PROJECT: Lake Worth Wastewater Pump Station No. 4
and Generator Replacement
Lake Worth Solicitation No. IFB-16-108
Lake Worth Project No. LS1503

DATE: March 11, 2016

ADDENDUM NO. 1

DATE:	JANUARY 2016
P.A. NO.	B5018.00
DWG. NO.	44-43-15-157
SHEET:	E1-1

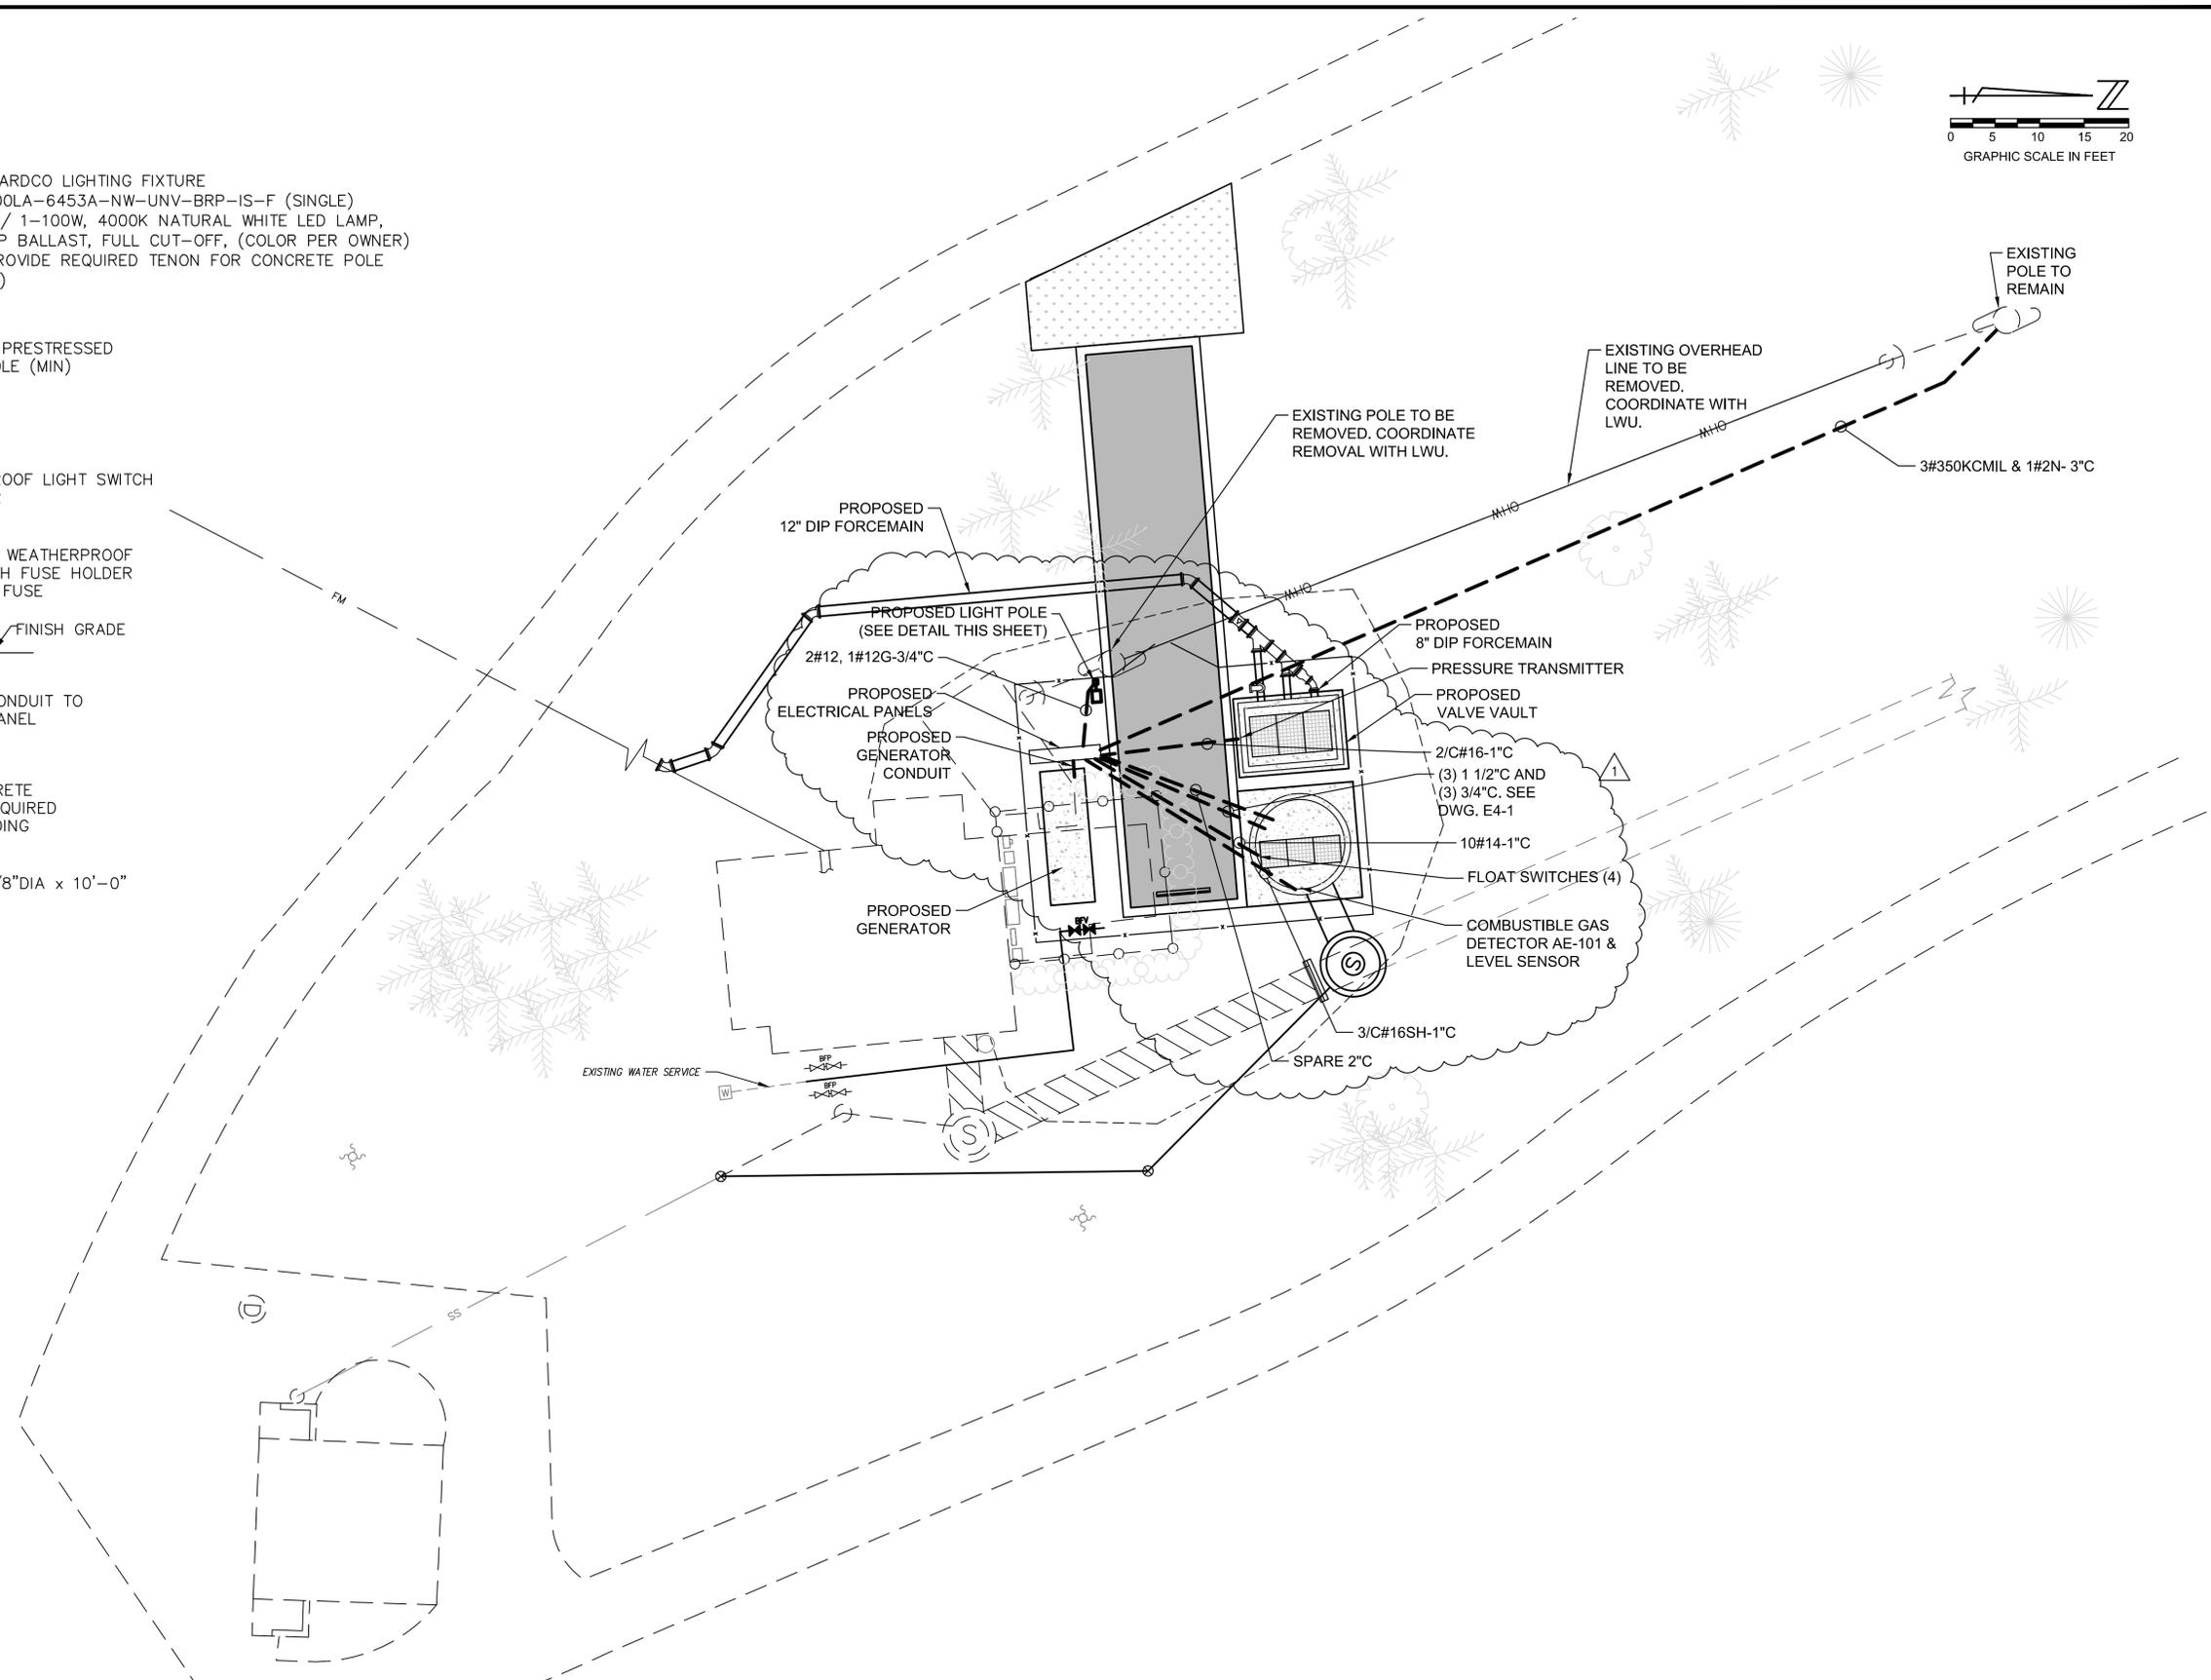
(1) Replace sheet E1-1 and E2-1 in their entirety. Electrical conduits have been added to the Electrical Site Plan and Electrical Equipment Rack detail.
